Docket Number:	12-AFC-02
Project Title:	Huntington Beach Energy Project
TN #:	201142
Document Title:	Applicant's Comments on PSA, Part A
Description:	Applicant's Comments on PSA, Part A
Filer:	Kimberly Hellwig
Organization:	Stoel Rives LLP
Submitter Role:	Applicant Representative
Submission Date:	11/7/2013 2:43:16 PM
Docketed Date:	11/7/2013

Re: Huntington Beach Energy Project (12-AFC-02)
Applicant's Comments on the Preliminary Staff Assessment (Part A)

FIGURE PSA RESPONSE VR-7 Proposed Color Treatment for Project Structures

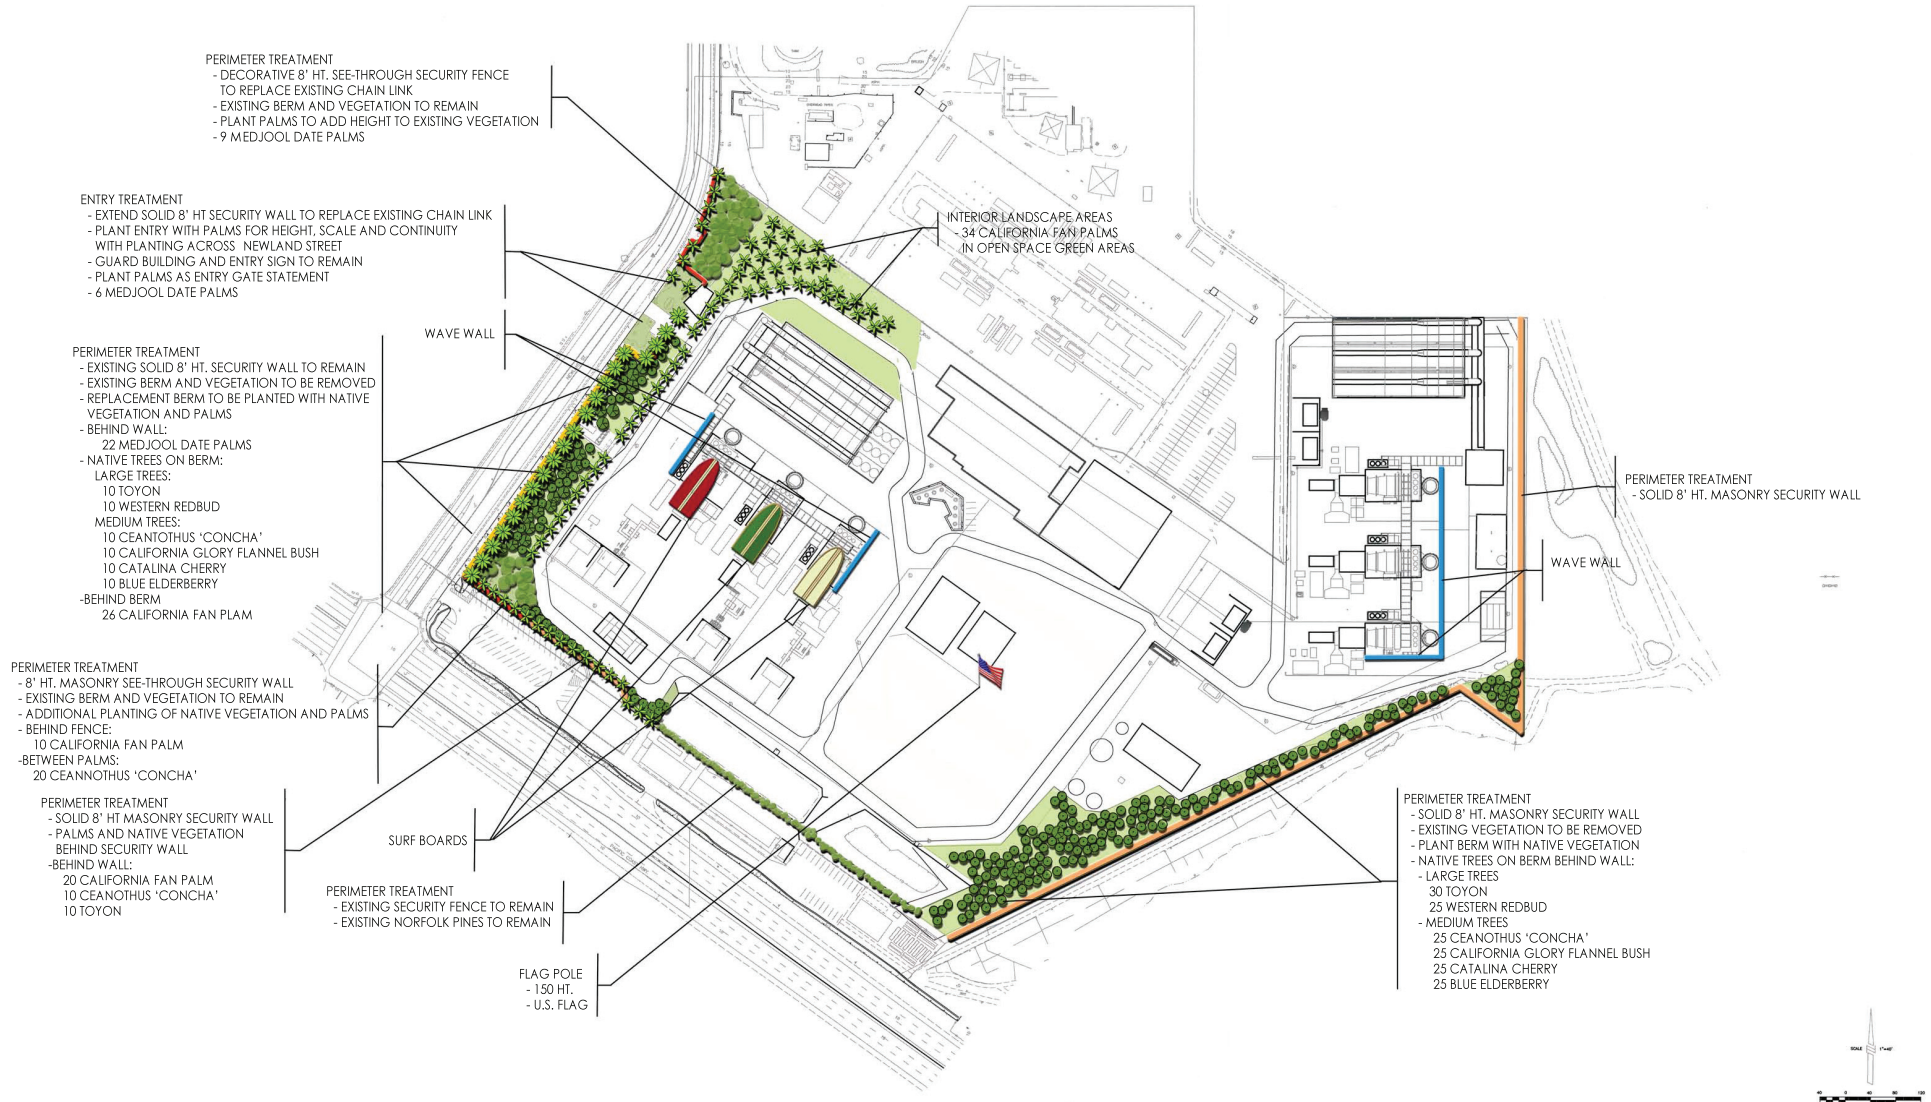
This language should be deleted because VR Figure 16 does not clearly reflect the Project landscape plans. The plans for this area as shown on Figure PSA Response VR-7 specify the proposed landscaping in some detail. As this figure indicates, the area behind the wall near the gate will be planted with a mix of California native trees and shrubs as well as a row of California fan palms. The KOP 5 simulation on PSA VR Figure 12b provides a correct representation of this planting. The arrow on PSA VR Figure 12b should thus be removed, along with the annotation stating “No Replacement Vegetation Proposed” and the language on page 4.12-23 related to this issue should be removed as well.
